Attachment 1 - Original Application drawings - Advertised Plans / Decision Plans

33-37 RUPERT STREET COLLINGWOOD VIC 3066

TO: John Theodosakis (Statutory Planning)
FROM: Christian Lundh (Urban Design)
DATE: 14 July 2020
SUBJECT: 33-37 Rupert Street, Collingwood
APPLICATION NO: PLN20/0165
DESCRIPTION: Application for construction of a ten (10) storey building (plus roof terrace). Features of the proposal include: use of the land for; food and drink premises (no permit required use i.e. under 100sq.m.); and office (no-permit required use). A reduction in the associated car parking requirement of the Yarra Planning Scheme.

To:	John Theodosakis	Date:	28/07/2020
Company:	City of Yarra	From:	Hansen Urban Design Team
Re:	33-37 Rupert Street, Collingwood

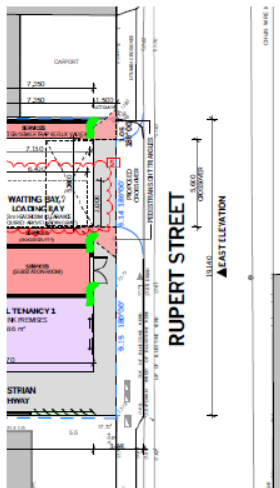
- Confirm that required sight-lines are achieved, the 'pedestrian sight triangles' on the plan appears to be obstructed by adjacent walls.
- Provide spot levels to demonstrate that there will be a seamless levels transition into / along the footpath and all grading will be compliant with relevant Australian Standards.
- Confirm if there may be outdoor dining furniture associated with Tenancy 1. Please show on plans to ensure no obstruction to the paths or circulation are created.
- Investigate potential opportunity to integrate moments of vertical greenery on ground floor façade to improve the public realm experience, noting that sight-lines and openings are not obstructed. Yarra Open Space team to provide final sign-off of potential planting. Refer indicative locations below.

Pedestrian pathway connection to Rokeby Street

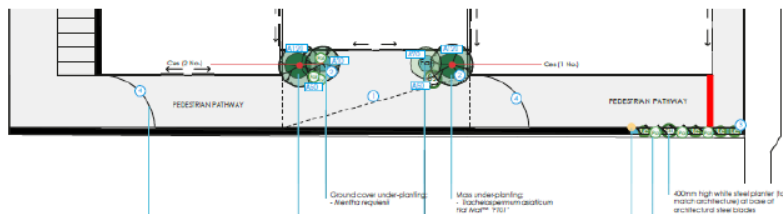
- Application documents note restricted after-hours access both to the street and to the rear (40-72 Rokeby Street). Confirm how this will be managed.
- Two gates are shown, will these be locked at the same time?
- Further design details are required relating to the gates, note on drawings not clear.
- Please re-position the east gate closer to Rupert Street (red line in screens hot below). This would assist to reduce the risk of anti-social behaviour and loitering in the after-hours accessible area otherwise created.
- Please confirm the ground floor lighting regime to ensure a safe environment is created for pedestrians traversing along Rupert Street after dark.

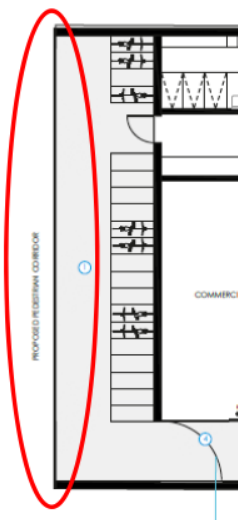
- Confirm way-finding strategy across this development and into 40-72 Rokeby Street, to ensure a holistic and eligible way-finding strategy is achieved for all occupants of the buildings and also the public that will use this 'short cut' to Rokeby Street.

- With the bicycle parking located at the rear of the property, please confirm how this will be managed to ensure cyclist will dismount at the Rupert Street entrance threshold?

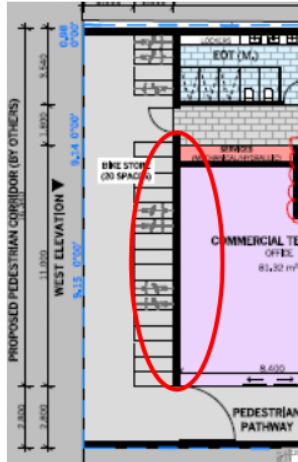
- Rather than having a blank wall, consider to explore providing some glass/ openings along this interface, so there is some level of activation along the rear interface and create a safer environment for anticipated pedestrian movement. Openings could be coordinated with the gate/openings into the Rokeby Street development.

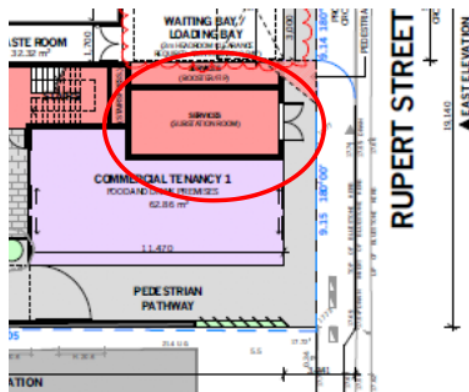
- Is there opportunity to lower the substation to the basement level / reduce footprint and extend the food and drink area into that space and further activate the street frontage?

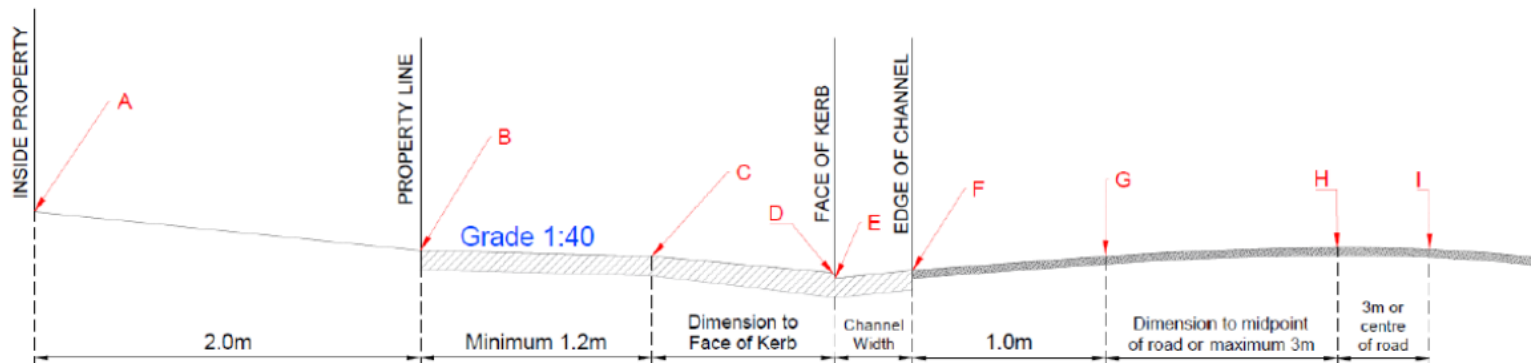
- o Please note the cross section must be fully dimensioned. As shown in the sketch below.
- o Please show both the existing and proposed surface.
- o The maximum allowable cross-fall between points B and C is 1:40 (2.5%).
- o A bullnose (max 60mm) is permitted at point D, however not compulsory.
- o The levels shown must be exact reduced levels, to three decimal points. Interpolation of levels is not acceptable.
- o The designer must demonstrate that an 85th or 99th percentile vehicle profile can traverse the design cross section as per the Australian/New Zealand Standard ground clearance template (AS/NZS 2890.1:2004).
- o Significant level changes to the existing footpath level B to C will require additional level design either side of the proposed crossing.
- o Please include any additional levels or changes in grade that are not shown in the diagram.

Streetwall and Massing

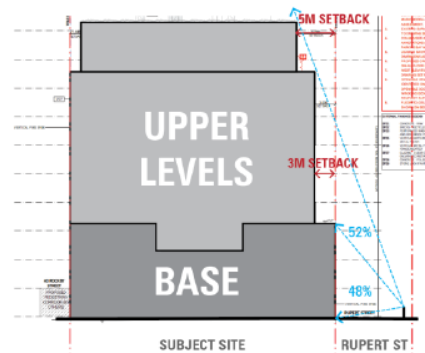
- The proposal has adopted a massing strategy has been 'broken' up into 3 components comprising a 3 storey 'base' to ground the development, a 5 storey tower (setback 3m behind the street wall) and a 2 storey recessive 'cap' (setback 2m behind the levels below from the street).

- DDO11 seeks to ensure that there is 'a consistent streetscape with active street-frontages and well-articulated buildings with street facades built to a height of up to 3-4 storeys'. Clause 22.10-3.3 further reiterates that new development to conform to existing development scale of adjoining sites. Our review of the existing streetscape identifies building heights (and streetwall heights) of 1-3 storeys. What can be gleaned from these policy and physical contexts is a 3 storey streetwall response that would be appropriate to the narrower street profile (10m wide) and represents a better fit within its existing and emerging streetscape. **We therefore support the proposed 3 storey streetwall as an appropriate urban design response.**

Proposed building heights and setbacks arrangement represent a proportionately more dominant upper levels when viewed from across Rupert Street.

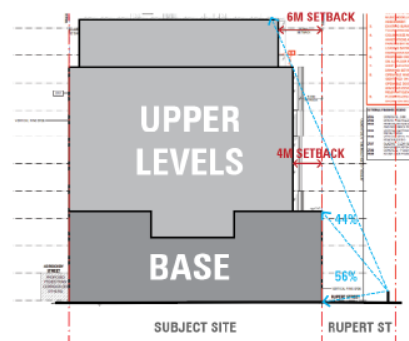
- Ensuring comfortable pedestrian environment that is not resulting in a 'canyon' effect and maintaining view to the sky is one of key urban design tests to achieve DDO11 objective 'to provide a pedestrian friendly environment along all street frontages'.

- DDO11 does not seek to visually conceal upper levels behind the street walls. However, the cumulative impact of a narrow street profile and a 10-storey tower development that proportionally and visually dominate the street wall does not contribute to a pedestrian friendly environment along Rupert Street. This effect will be further exacerbated when replicated on adjoining sites, or across the road.

Overshadowing

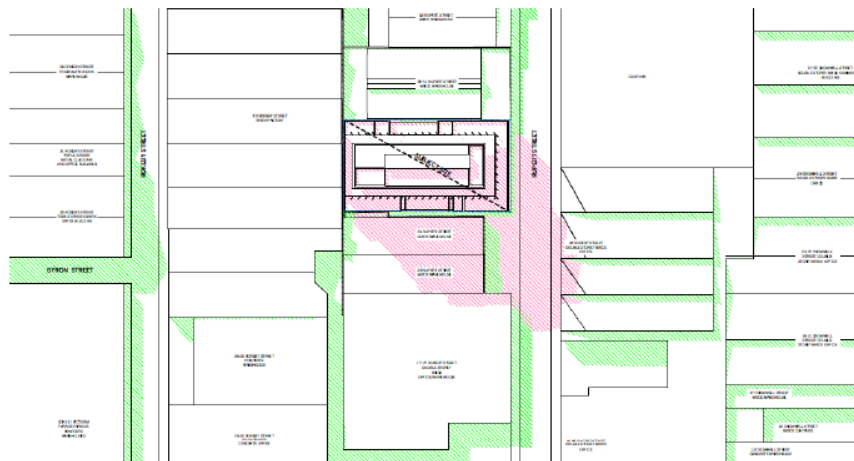
- Shadow diagrams provided in the architectural drawing package demonstrate additional overshadowing impact onto public and private realms on the equinox (22 September) between 9am to 3pm, including on Rupert Street eastern footpath and part of western periphery of No. 24 Rupert Street (2pm onwards).

- DDO11 does not prescribe time of the year and the day when solar access to existing footpath, public spaces or private properties must be retained. The Urban Design Guidelines for Victoria Objective 1.5.4 suggests *future building height and setback distances so as to allow daylight and winter sun access to key public spaces within streets (objective 5.1.3)*. We acknowledge that Rupert Street is not identified as a key public space and we accept that the winter solstice solar test, which represents a more onerous measurement is not warranted in this context. In this instance, we accept that solar tests taken on 22 September (equinox) is appropriate and consistent with other solar tests undertaken in the City of Yarra’s context (refer to DDO15 as an example for acceptable solar tests in an Activity Centre context in the City of Yarra).

Site Planning and Functionality

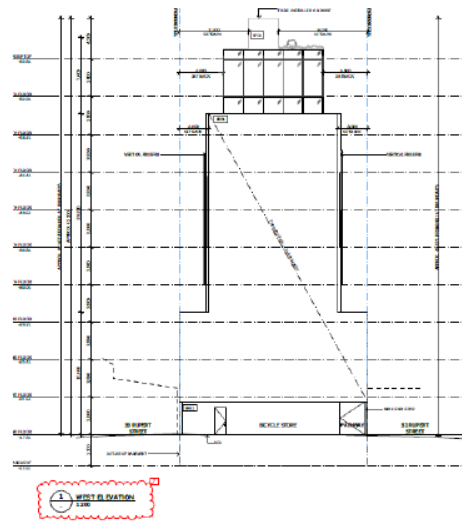
- We are generally supportive of the site planning strategy, including active uses to the street, a pedestrian pathway and an underground basement to allow greater activation and surveillance to the street. While it is generally accepted that a portion of the ground level will be occupied with vehicle access and services, we feel further improvement to improve the street level presentation is required, where more than half of the street frontage is inactive.

- We appreciate that the frontage width makes it difficult to have a clearly visible ‘foyer’ to the offices, however the pedestrian pathway should have a strong sense of address from Rupert Street. **As a suggestion, there is opportunity to extend the brick paving on the pedestrian pathway as a wayfinding element between Rupert Street and the Foyer. More information is also required to demonstrate how services are concealed and proposed material treatment to manage the Rupert Street interface at ground level.**

Architectural Expression

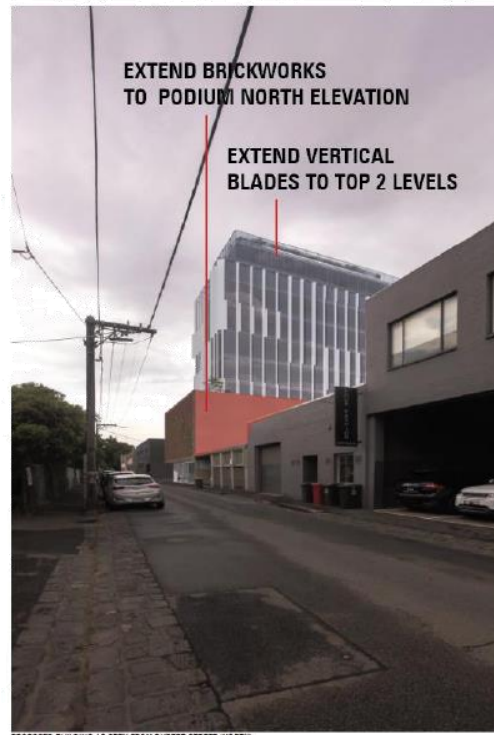
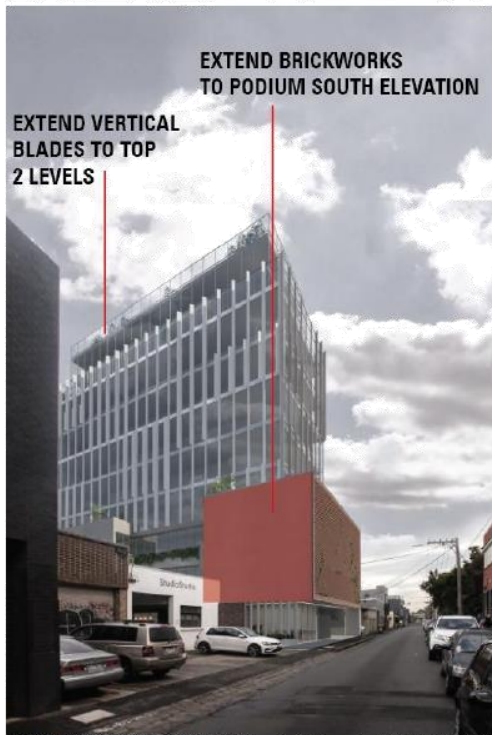
- We are generally satisfied that the presentation of the proposed architectural treatment in achieving unambiguous visual distinction between the 'base' and 'top'. Compositionally, we commend the utilisation of 'bricks' as in response to predominant material palette within the context of Rupert Street streetscape. The application of a 'hit and miss' brick works that enables visual permeability is successful in achieving a restrained façade design without discounting on the human-scaled articulation and sense of depth to the building. Currently, existing buildings to the north and south of the subject site are setback from their Rupert Street frontage, revealing the proposed 3-storey northern and southern elevation. **Further refinement to improve the three-dimensional quality of the street wall will be to extend the brick application along the northern and southern party wall to manage its visual presentation in the short to medium terms.**

- Within the 'middle' section, we are broadly supportive of the unified glazed box with an additional façade skin comprising vertical blades for visual interest, shading features and to minimise visual bulk. When viewed from further afield, we are satisfied that the angles and arrangement of the façade system are legible when viewed from further afield, ensuring the necessary level of articulation is achieved without resulting in visual clutter.
